**TSG-RAN Meeting #6  
Nice, France, 13 – 15 December 1999**

**TSGRP#6(99)759**

**Title:** Agreed CRs of category "C" (Modification) and "F" (Correction) to TS 25.427

**Source:** TSG-RAN WG3

Figure 11: Uplink data frame structure

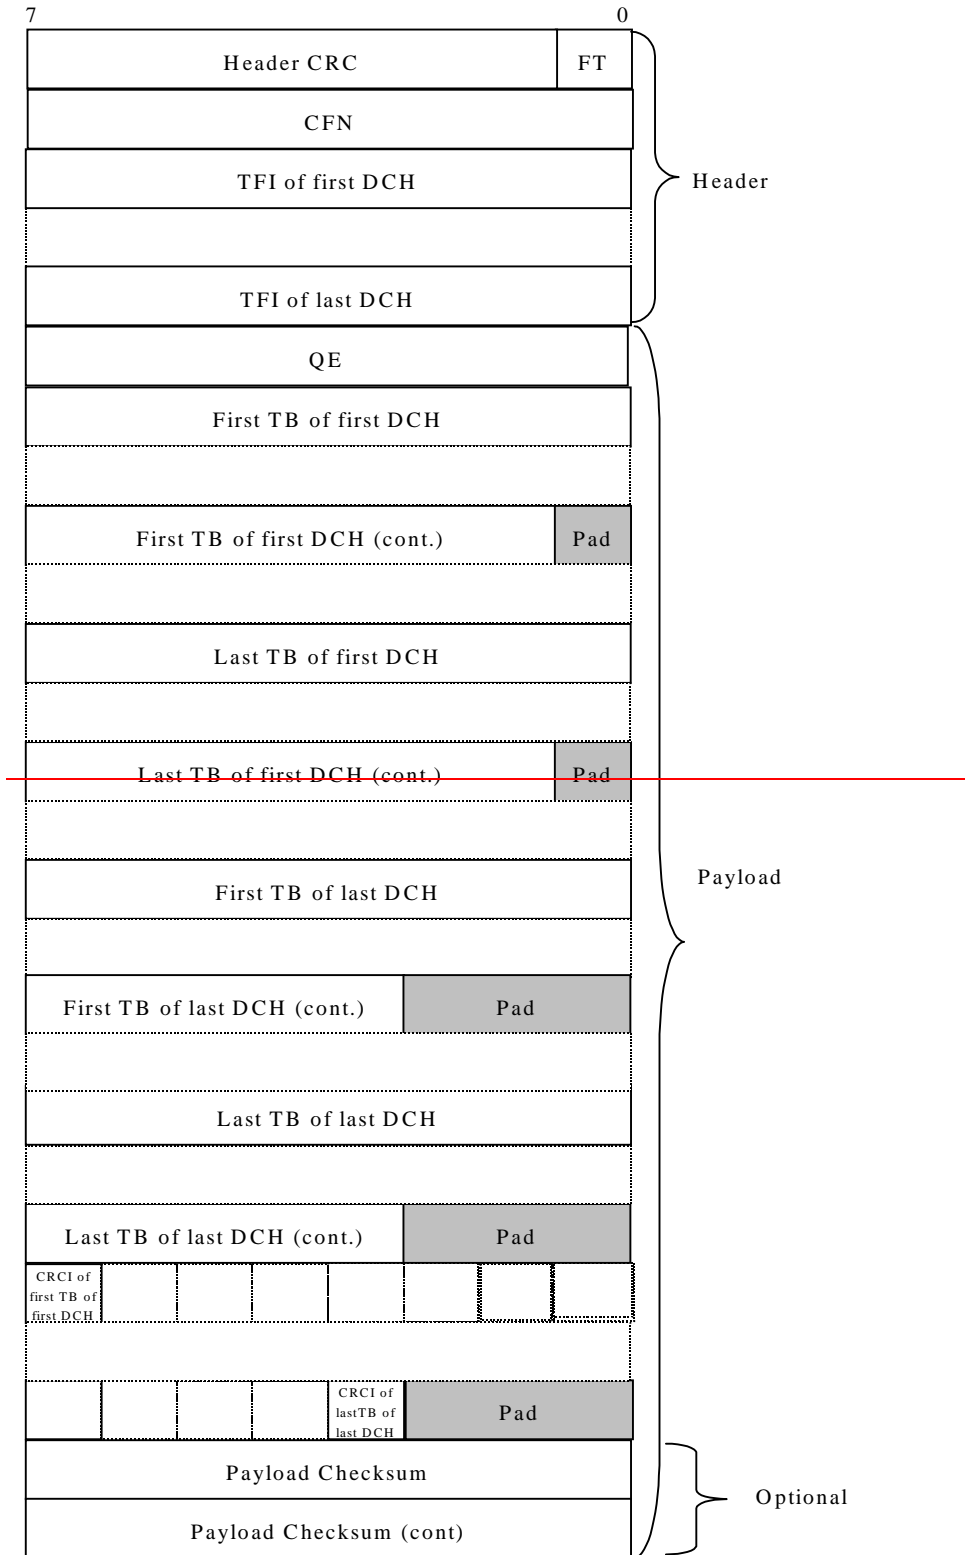
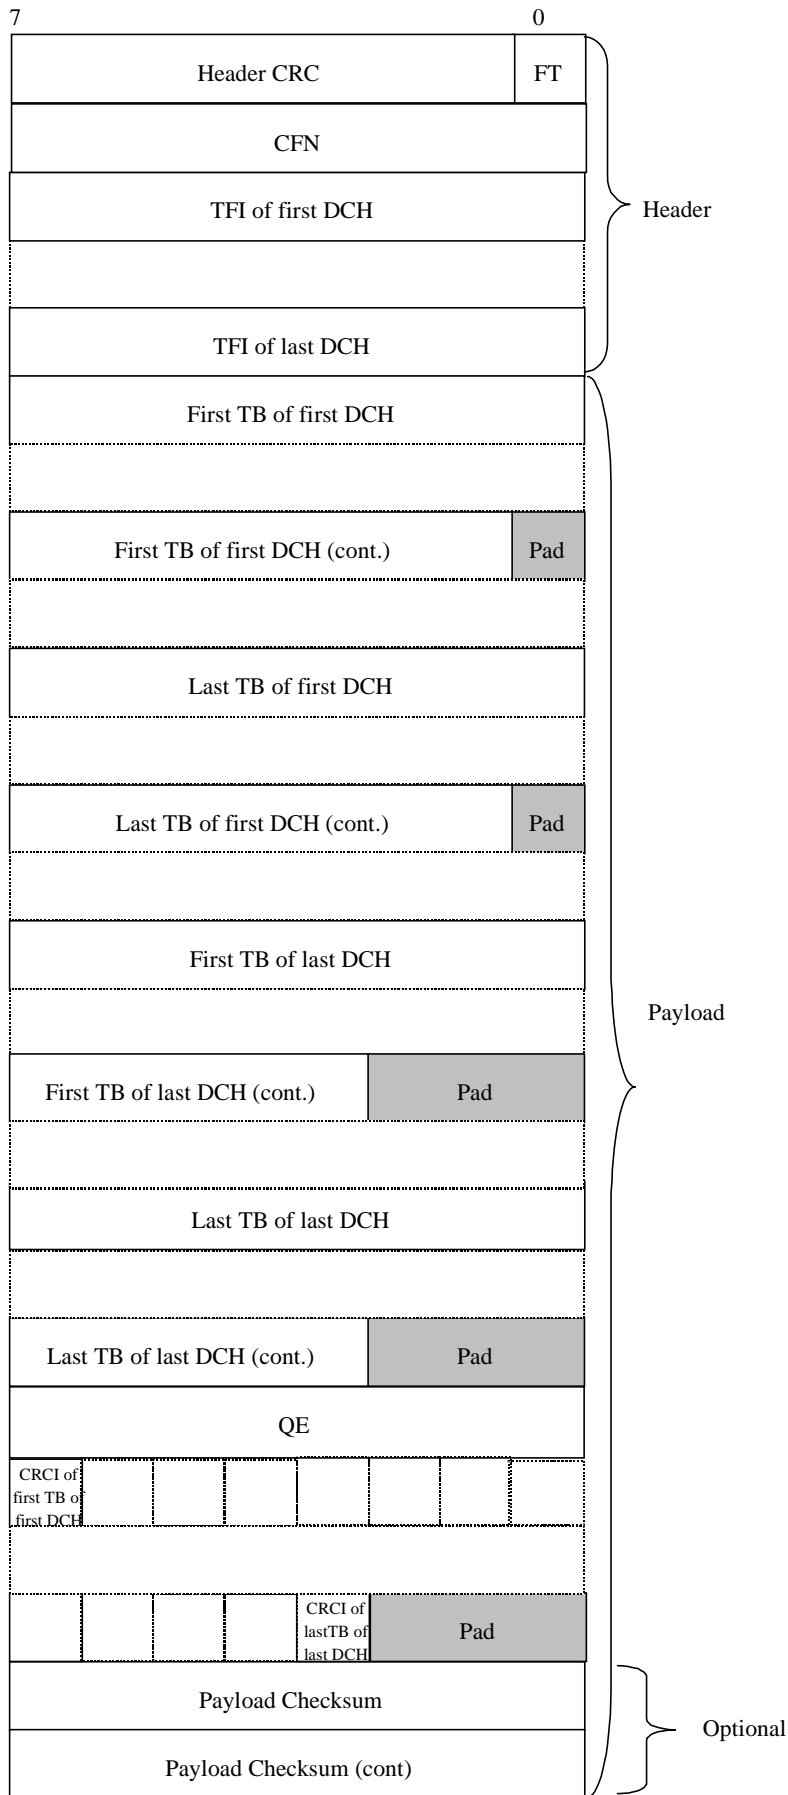
During the R3#7, based on Ericsson contribution TSGW3#7(99)C13, it was agreed to move the CRCI to the end of the payload. Main motivation was to enable parallel processing of the CRCI calculation on the later blocks in the frame while already having started the calculation of the payload CRC on the earlier blocks of the lub frame. For larger lub frames, a relevant processing delay reduction should result.

For the same reason, we are now proposing to move the quality estimate to the end of the lub frame payload. This should again enable parallelism: between calculating the quality estimate (which could be based on the decoding of the last TB in the frame if that would result in the most accurate quality estimate) and the payload CRC calculation.

One additional identified benefit is that all quality related information (CRCI and QE) is now placed together.

Figure 11 in section 6.2.2.

**Figure 3: Timing Adjustment**

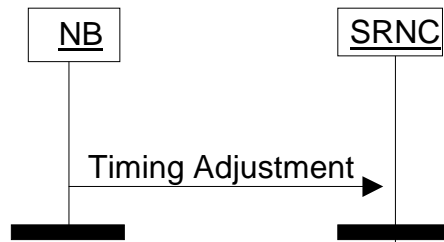
**Reason for change:** This CR addresses triggering of UL synchronisation control frame transmission by node-B as a result of receiving a "DSCH TFI Signalling" control frame.

When the DCH is used in combination with a DSCH, there might be longer periods in which no data is sent on the DCH. However if data is sent on the DSCH during this period, the transmit time of the "DSCH TFI Signalling" control frame on the DCH transport bearer should still be under node-B control. If the receipt of this control frame becomes too late/early, it should be possible for the node-B to control the transmit timing of the frame at the SRNC with a "Timing Adjustment" control frame.

If a DL data frame or a DSCH TFI Signalling control frame arrives outside the determined arrival window, ~~node-B should evaluate the time difference between the optimal arrival time for the DL DCH FP frame to be transmitted in the indicated CFN and the actual measured arrival time of the DL DCH FP frame (ToA: time of arrival).~~

, the Node B reports the measured ToA and the indicated CFN in one UL DCH FP control frame.

**Figure 11: Uplink data frame structure**

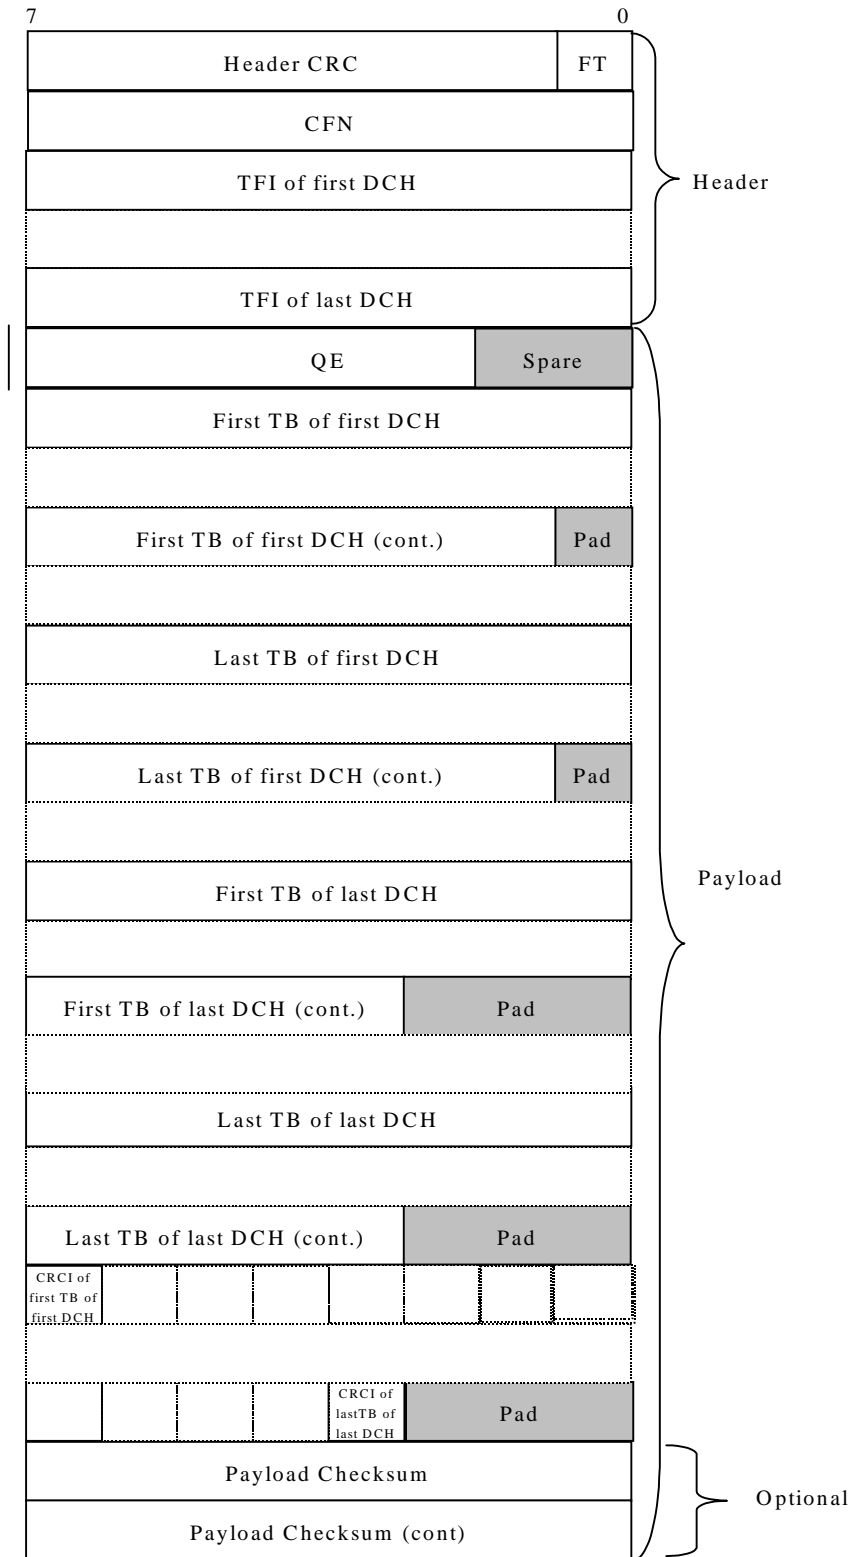
**Reason for change:**      Alignment of quality estimate with 25.215 in terms of range and granularity.
